HOWARD COUNTY, MARYLAND

ADDENDUM NO. 1

REQUEST FOR PROPOSALS NO. 03-2018

GROUNDWATER REMEDIATION SYSTEM HARDWARE/SOFTWARE MODERNIZATION

Figure 1: Carrs Mill Landfill GWB Enclosure Door Outside

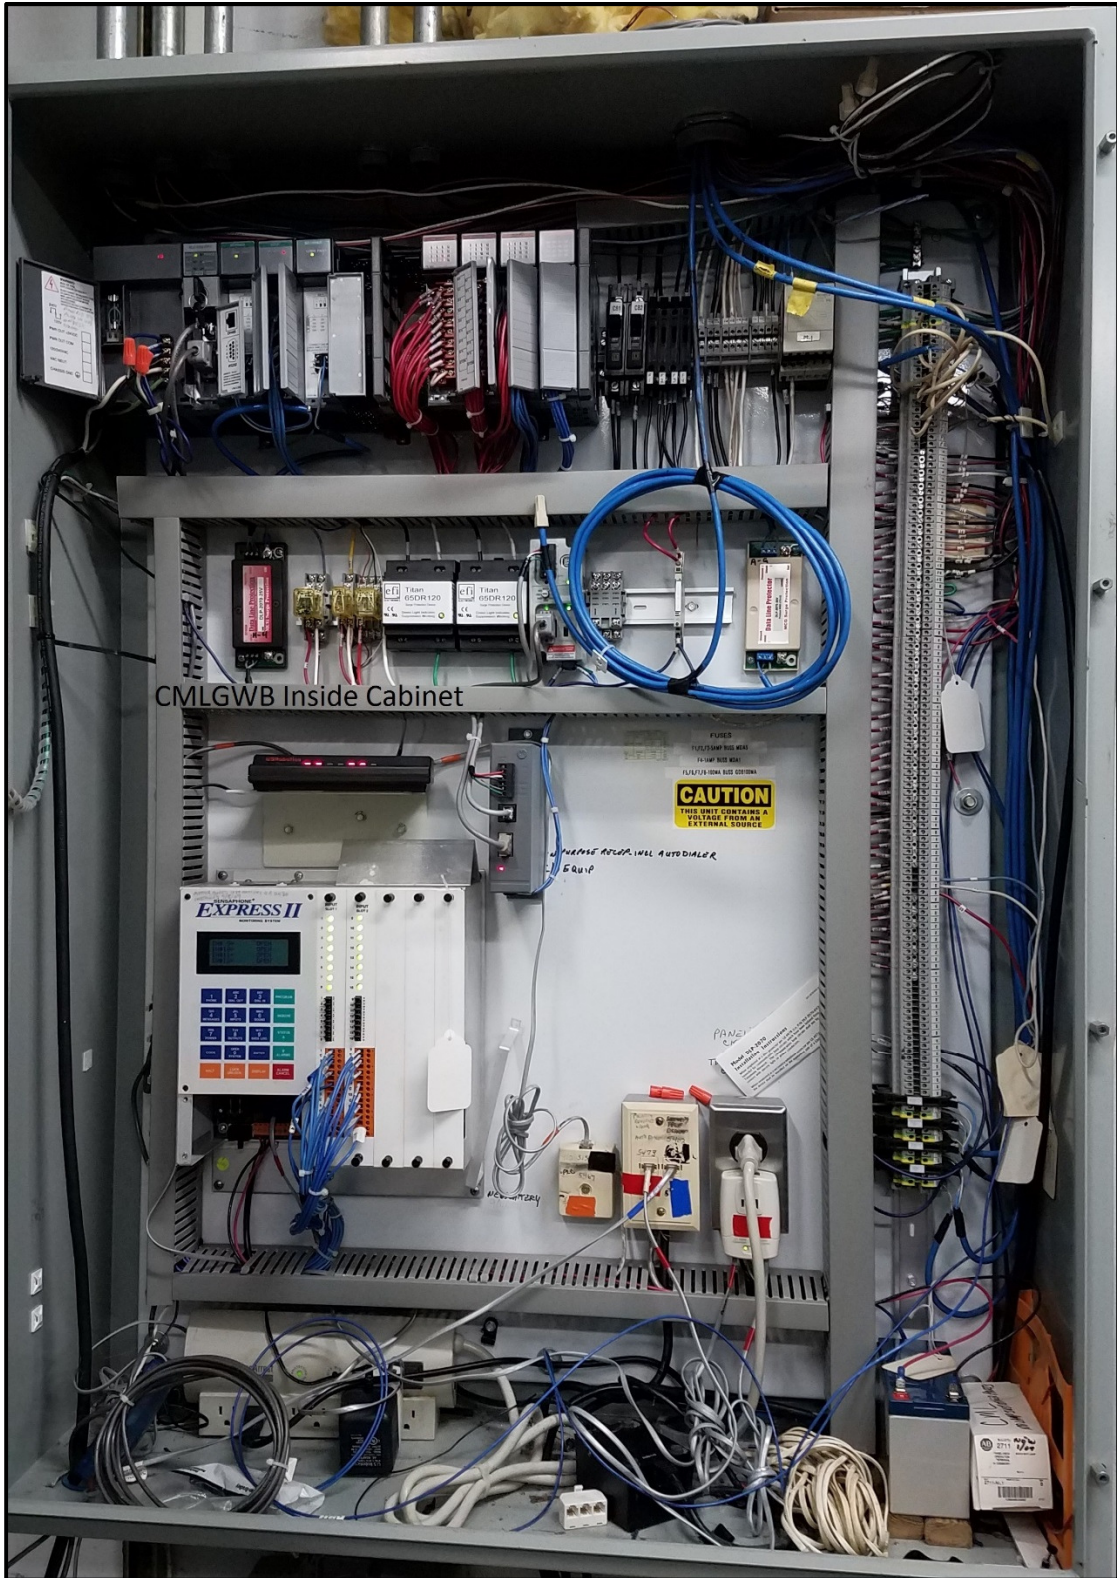
Question 11: Section 01000-2.4.2 – Spec section states that One (1) new, steel, powder coated door skin to attach over existing door to cover existing door penetrations. Size per enclosure described in previous bullet. What exactly is to be provided?

Answer: The text referenced is in Section 13400-2.6.1.4.2. The CONTACTOR shall provide a covering over the existing enclosure door in order to cover the opening that will be created by the removal/demolition of the existing OIT that currently penetrates the enclosure door. Perhaps the attached photos of the enclosure will provide clarity.

ATTACHMENT IV

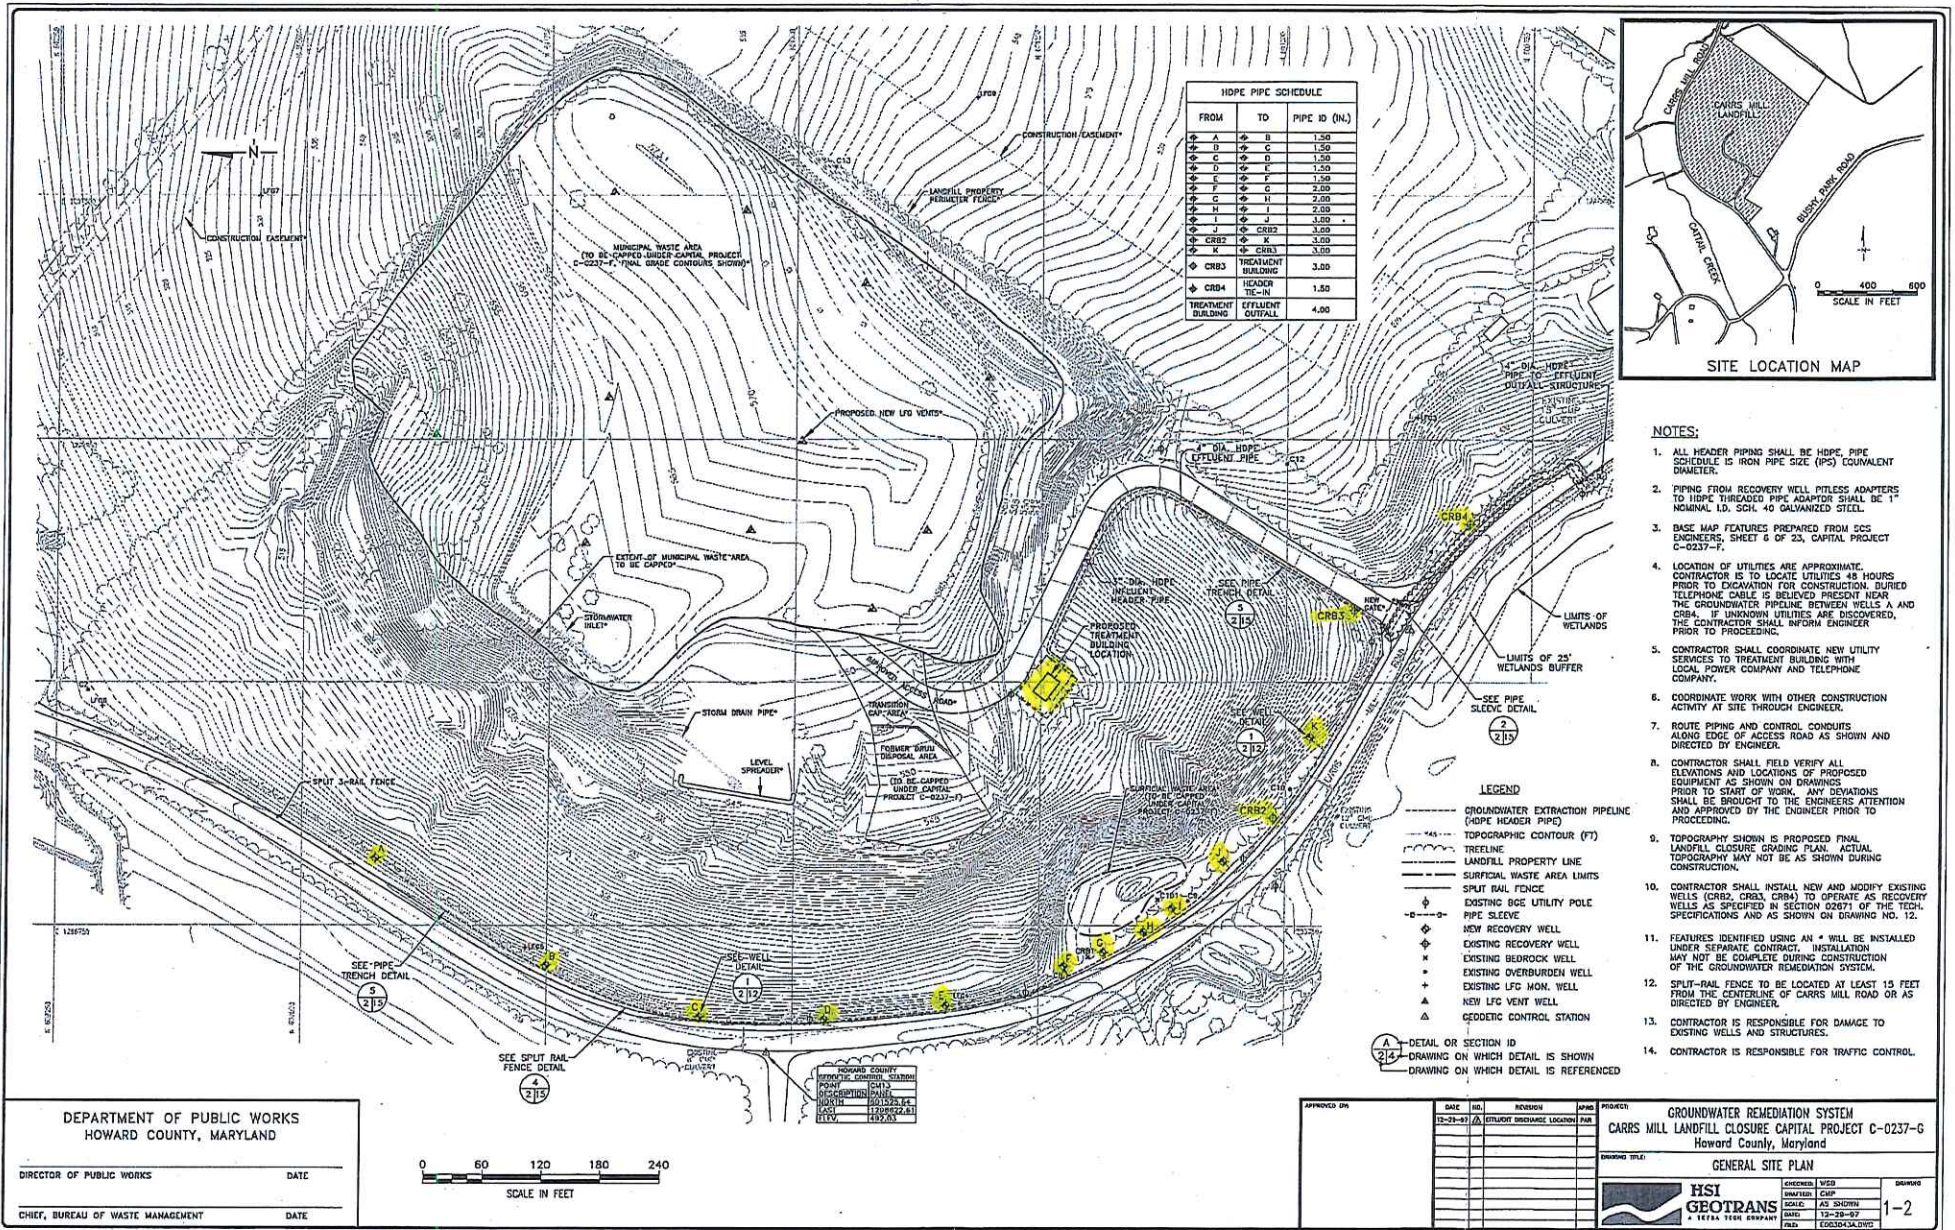
Question 19: What is the distance between each well and CRB-3 for conduit runs and CAT6 cable lengths? (13400.2.4.3.1.1 page 45). Please provide a diagram on the conduit runs and wires?

Answer: A figure for each site is provided in Attachment IV. Below are the approximate distances to assist the CONTRACTORS in bid preparation. These are straight line distances between well vaults and are not exact distances of conduit runs. Further, these distances do not account for any distances inside vaults, or other needs.

Connection	Distance (feet)
1	177
2	143
3	189
4	52
5	74
6	74
7	40
8	47
9	39
10	138
11	130
12	129
13	168
14	213
